**Proposal for Amendment [x] to global technical regulation
No. 9 (Pedestrian safety)**

**Proposal for further amendments to document
GRSP-54-33, submitted by the informal working group on global
technical regulation No. 9**

Figure 5A: Corner of bumper (see paragraph 3.13.)

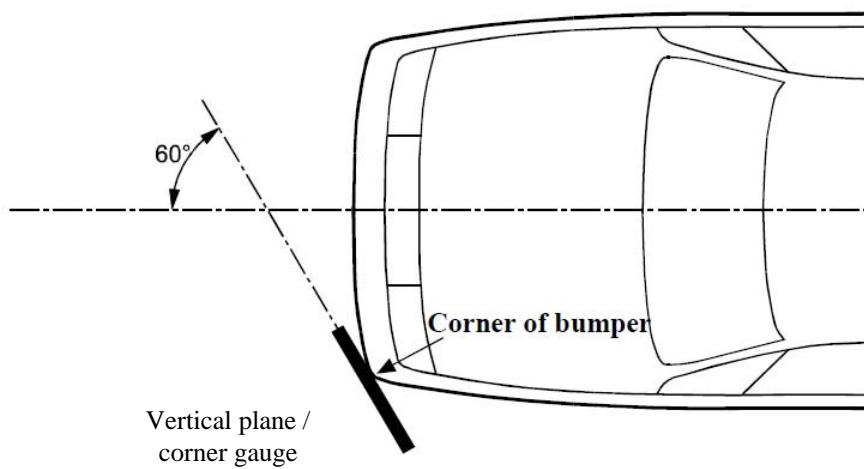
- 3.134. "Corner of bumper" means the vehicle's point of contact with a vertical plane which makes an angle of 60° with the vertical longitudinal plane of the car and is tangential to the outer surface of the bumper (see Figure 5). ~~corner gauge as defined in Figure 5B.~~

The transversal position of the corner of bumper is determined with a corner gauge as defined in Figure 5B.

For determination of the corner of bumper the front surface of the corner gauge is moved parallel to a vertical plane with an angle of 60° to the vertical longitudinal centre plane of the vehicle (see Figures 5A and 5C) at all heights of the horizontal centre line of the corner gauge in the following area:

- a. Equal or above a point found in vertical direction on the Lower Bumper Reference Line at the assessment position in transversal direction or at 75 mm above the ground reference plane, whichever is higher.**
- b. Equal or below to a point found in vertical direction on the Upper Bumper Reference Line at the assessment position in transversal direction or at 1003 mm above the ground reference plane, whichever is lower.**

For determination of the corner of bumper the gauge is moved to contact the outer contour of the vehicle touching at the vertical centreline of the gauge.

The corner of bumper is then defined as the outermost point of contact of the gauge with the outer contour of the vehicle according to this procedure.

Figure 5B: Corner Gauge

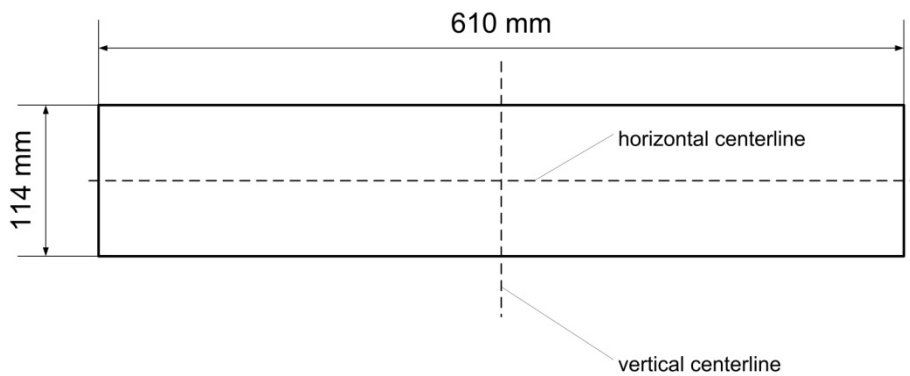
The front surface of the corner gauge is flat

Figure 5D: Determination of bumper test area]

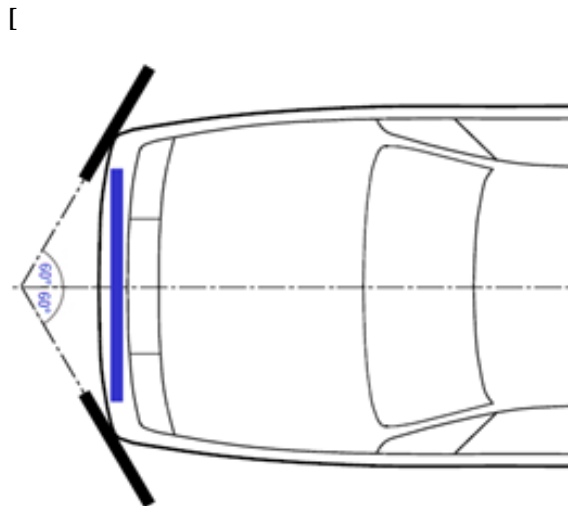
- 3.101. "Bumper test area" means ~~the frontal surface of the bumper limited by two longitudinal vertical planes intersecting the corners of the bumper and moved 66 mm parallel and inboard of the corners of the bumpers. [either] the area limited by the bumper corners as defined in paragraph 3.14. and moving on either side 42 mm inboard parallel to a lateral vertical vehicle plane [or the outermost ends of the bumper beam/lower rails/cross beam structures as defined in paragraph 3.9. (see Figure 5D), or between a bumper corner and outermost end of the bumper beam, whichever area is larger].~~
